Dwelling type:	House and Garage.
Dwelling configuration:	Double Storey
Nature of works:	New Building.
Stage of inspection:	Fixing & Waterproofing.
Construction Type:	Multiple Claddings.
Garage:	Attached.
Foundations:	Slab.

Defects, observations and other related comments from the Fixing & Water Proofing Inspection on the 16/03/2021:

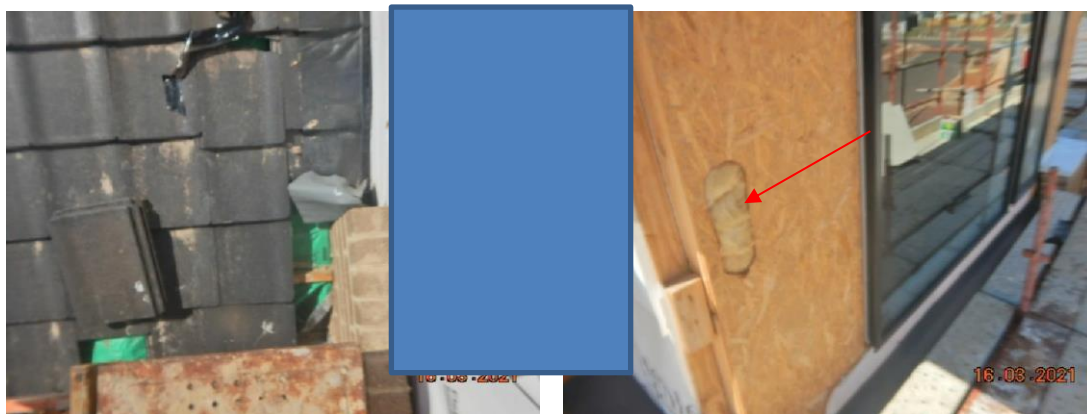
1. This item has not been addressed as of the 16/03/2021.

We noted sisalation missing to a large number of external walls.

Builder will need to install the sisalation to comply with the dwellings energy rating and following requirements.

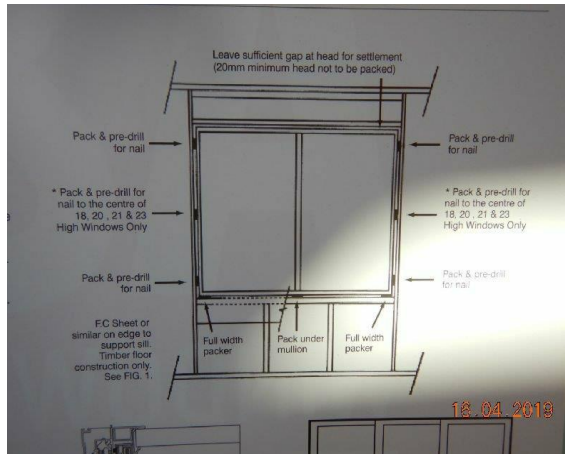
The window reveals and door frames around the dwelling have not been packed as per the manufacturer's installation requirements.

This dwelling's windows do not comply with these basic instructions. Additional works need to be completed to ensure that my client's new windows are installed in a manner that is approved by the supplier, thus protecting any and all warranties on the product.

The window supplier has a detailed *installation* instruction manual, usually stuck to a minimum of one window to each and every dwelling. Those instructions clearly state that the windows and door frames are to be supported in the frame via packers, this will include the bottom and both sides.

Carpenters often state this will be completed at fixing stage; this is the same time the area is covered over with architraves. All windows need to be set to brick nominal measurements and fully packed. If required these packers can be adjusted if a slight adjustment is required to a window or two. In short there is no reason not to comply with the manufacturer's requirements when installing.

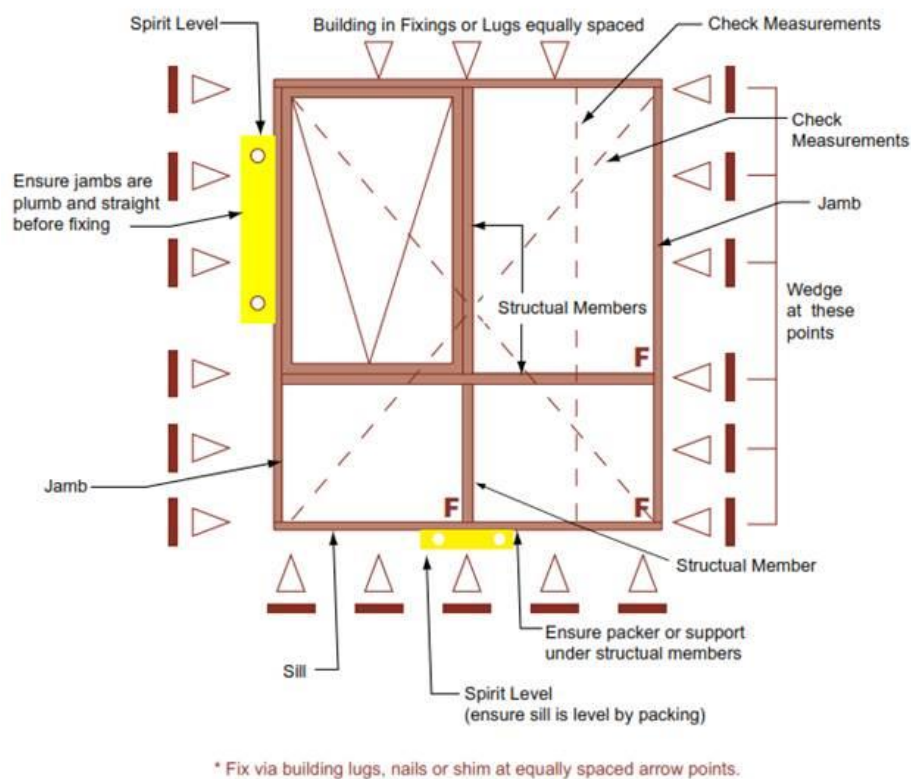
AS 2047: - The carpenter has installed the windows and door frames with finishing gun nails. Finishing gun nails have no load resistant capacity and should not be used in this manner.

The installed frames to this dwelling do not comply with the inserted from the Australian Window Association table that considers the wind loadings in AS 2047. "Finishing" nails are not part of the fixing process as they are not 1.8 mm thick.

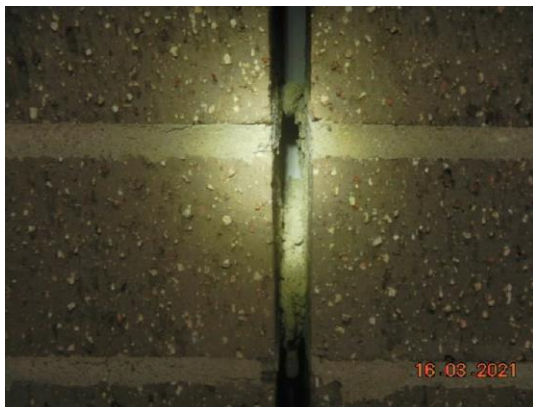
It was noted that most of the Articulation or Control Joints in the dwelling have non-compressive material (mortar) still in the joints.

Failure to remove the hardened mortar will result in brick-and-mortar cracking if the dwelling needs to expand by its full measure. If the AJ's (CJ's) are blocked, the movement must dissipate elsewhere. Hence cracking occurs.

All of the AJ's must be stripped, cleaned of all non-compressive material and then presented to the dwelling's owner for inspection and only then sealed.

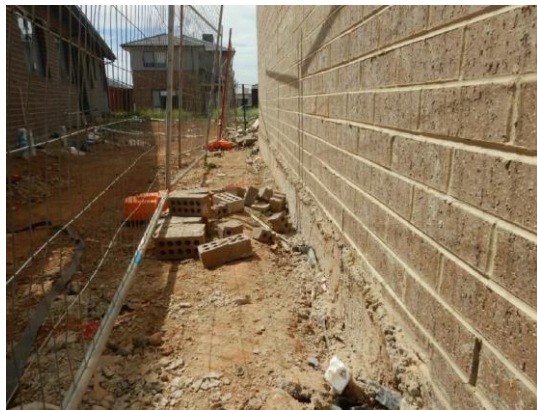
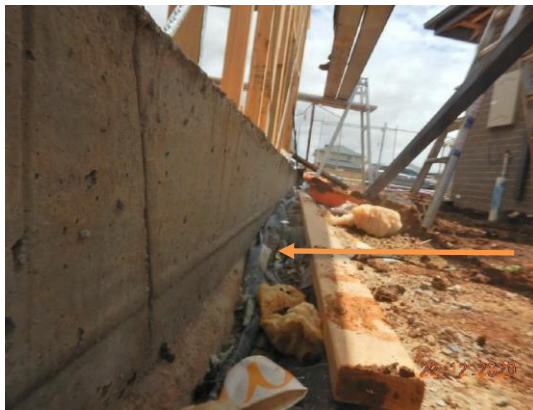
The land to the garage falls back towards the foundations of the slab. Given that this is a zero boundary, the builder must work in provisions for draining the soil to this area.

I noted that the Engineering states that a 50 mm fall away from the footings must be installed. The builder needs to assist us with an understanding of how, with a zero boundary the builder expects to achieve this requirement.

The builder should have allowed a 150 mm set back to the Garage wall to boundary and installed a water management system to divert water away from the foundations and slab edge as an alternate solution to the mandated requirements.

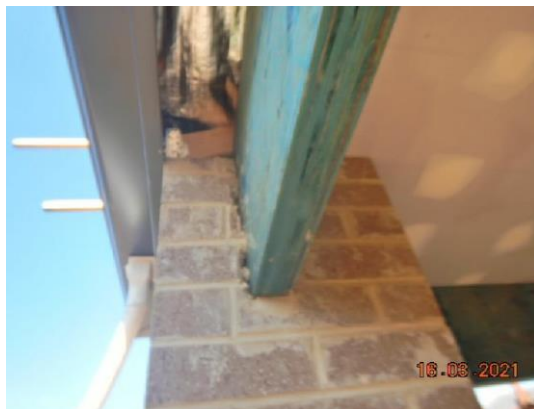
It was noted that no allowance for brick growth and frame shrinkage has been allowed to the framing members to brickwork connection as documented below.

AS 4773.1:2015, part 2.3.2 calls for the builder to design an allowance. This should then be represented onto the plans. I noted that this was not the case. The builder will need to rework this item.

Bowed Wall

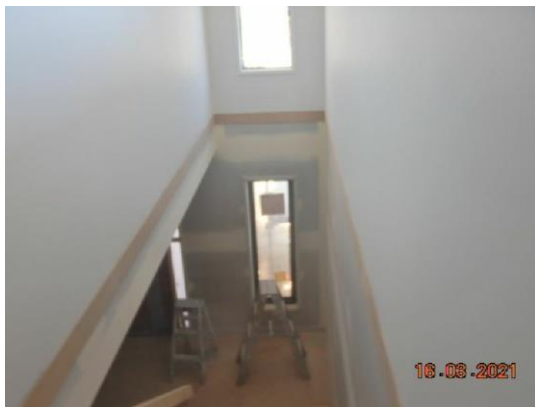
Many window manufactures require a 7 mm cement sheet or pine board strip placed in the cavity to support the heavy glazed section; this was not present at the time of inspection. This often also results in bows to the top styles long after the windows are installed.

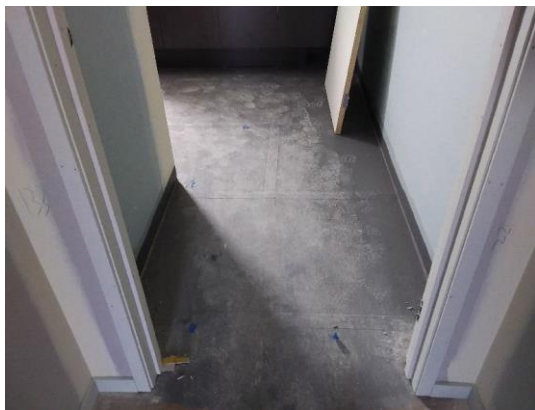
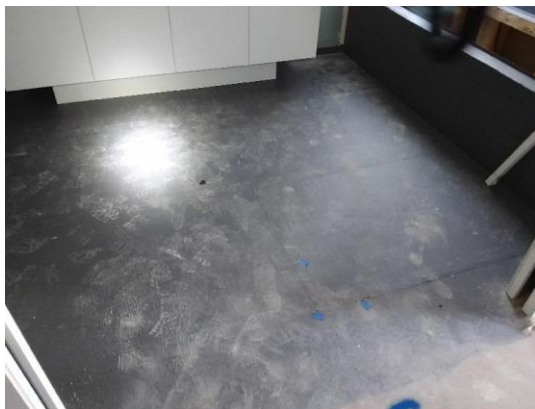
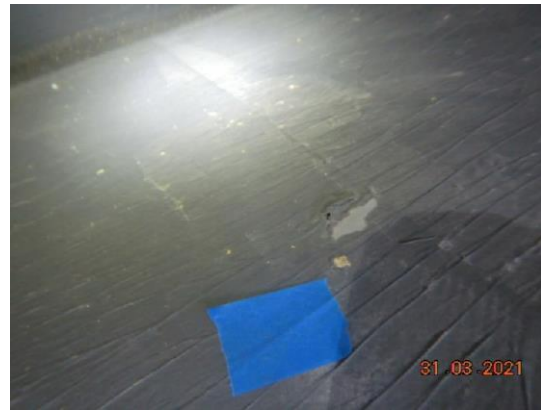
We noted some small holes, cracks or gaps in various sections to the water proof membrane in wet areas (marked with blue tape).

All areas must be sealed waterproof in accordance with the NCC Volume 2 and the manufactures specifications.

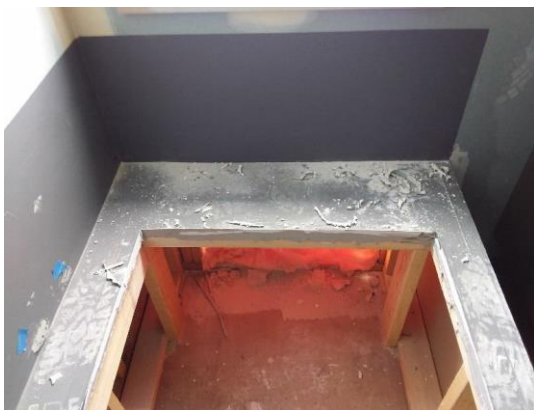
We noted dirty boot prints, builders waste and a door presenting on the waterproof membrane, as documented in the photographs below. The concern is potential damage to the membrane from scratches, possibly from dirt abrasion or scuffs from debris caught in the soles of foot ware. All areas should be protected.
